The Arcade-Cripple Creek Trail Project is nearing the end of the design phase and gearing up for Construction! Between December 6, 2021 and January 4, 2022 the draft plans were on the City's website (<http://www.citrusheights.net/940>) for review and comment.

Table 1 lists the comments received on the DRAFT plans which were submitted to the Project Team during this public review period. Letters/Emails received are coded with letters (A, B, etc.).

ARCADE-CRIPPLE CREEK TRAIL PROJECT

Response to Public Comments on Draft Construction Plans

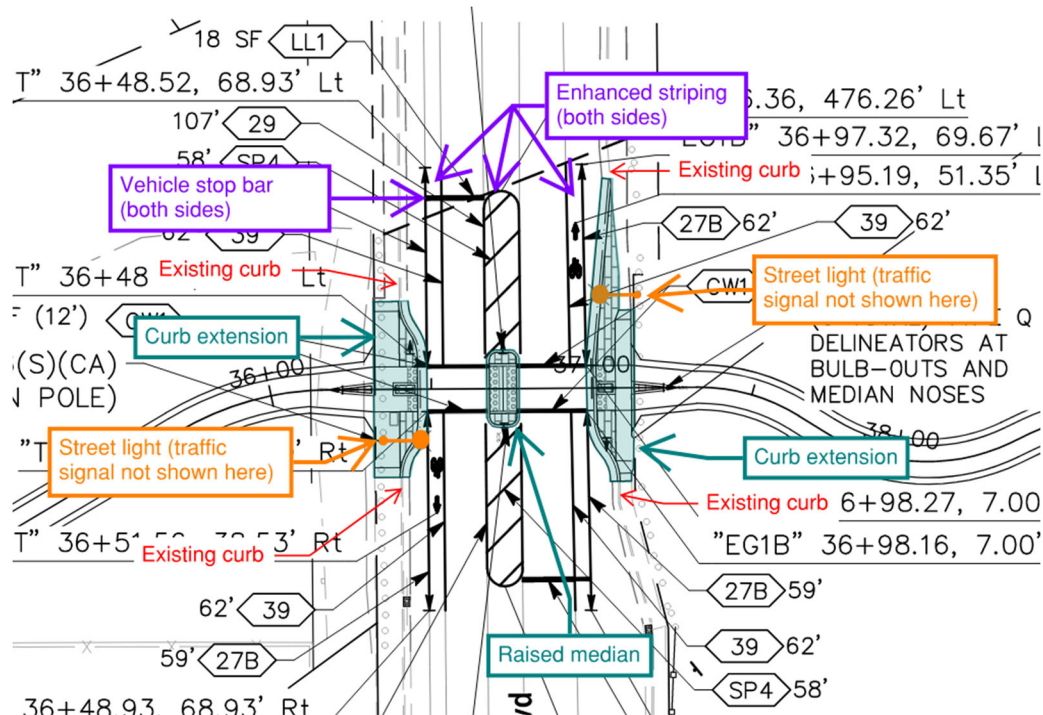
- I don't know if the crosswalk lights on sheet C17 will be sufficient to protect pedestrians and bicyclists crossing at this point, folks drive very fast through here. A-1
- I have a similar concern with the crossing on Woodmore Oaks (sheet PD2), folks routinely run the stop signs through here. Will there be sufficient lighting for pedestrians to be visible when crossing? I do not see streetlights near the crosswalk in sheet E8. A-2
- Will the dirt pedestrian paths in Sundance Park remain after this project is complete? A-3
- Will the parks remain accessible during construction? A-4
- Why is a CCTV camera only on the crossing at Villa Oak Dr? A-5
- Will the trail lights be shielded to keep the light on the trail and not affect nearby residences? A-6
- What is the expected lifespan of the batteries in the solar lights and what is the long-term maintenance plan? A-7

Response A-1: Sheet C17 shows details regarding the new signalized trail crossing of Fair Oaks Blvd.

This project will install a new traffic signal for the trail crossing. When a trail user arrives at either side of the crossing, they will press a pushbutton to activate the signal to change from green to yellow and then red. When faced with a red light, vehicles must come to a complete stop. Once the light turns red for vehicles, the trail user will get a signal that it is safe to cross the roadway. In order to bring awareness to drivers of the upcoming traffic signal, yellow flashing beacons will be installed 200 feet in advance of the traffic signal in both the northbound and southbound directions. The new traffic signal also includes the addition of two new streetlights, to be installed on either side of the roadway, increasing overall lighting of the crosswalk during dark hours. All of this increases safety of the proposed crossing.

As an additional safety measure for trail users, the project will also install curb extensions, a median, and striping enhancements, as shown on sheet PD2 and in the image below. These changes will reduce the crossing distance for trail users and increase visibility of trail users to vehicles. Reduced vehicular lane widths have been shown to slow traveling vehicles.

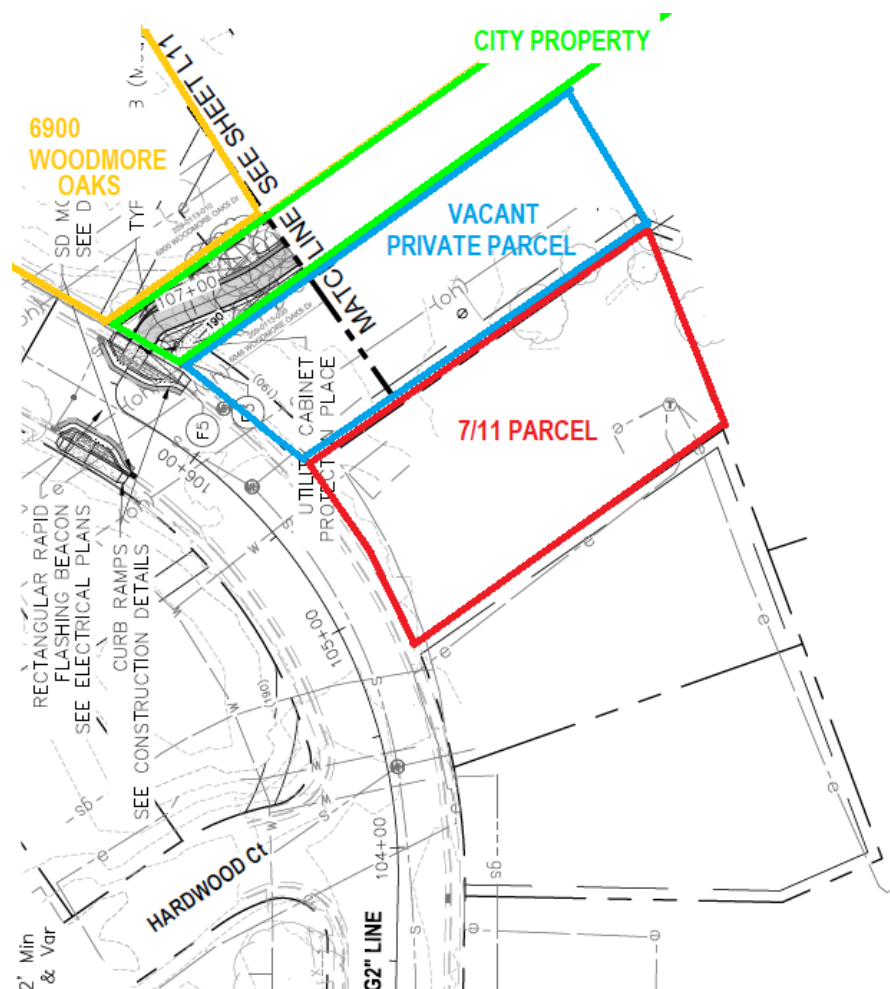
How will the new trail impact the open area next the the 7-11 on Woodmore Oaks?

C-1

Response C-1: The proposed Arcade-Cripple Creek Trail will be located within the City owned parcel (shown in green, below) along the fence/southern property line of the property at 6900 Woodmore Oaks Drive located on the corner of Woodmore Oaks and Drywood Way (shown in orange/yellow in the diagram below).

There is an existing vacant lot just north of 7-11 and south of the trail alignment (shown in blue) that will not be impacted by the trail project. The vacant lot next to the 7-11 parcel is privately owned and neither the City, the County, nor Orangevale Recreation & Park District have any rights to construct improvements on this privately owned parcel. The City owns only the 30' wide parcel where the trail is currently proposed (shown in green, below).
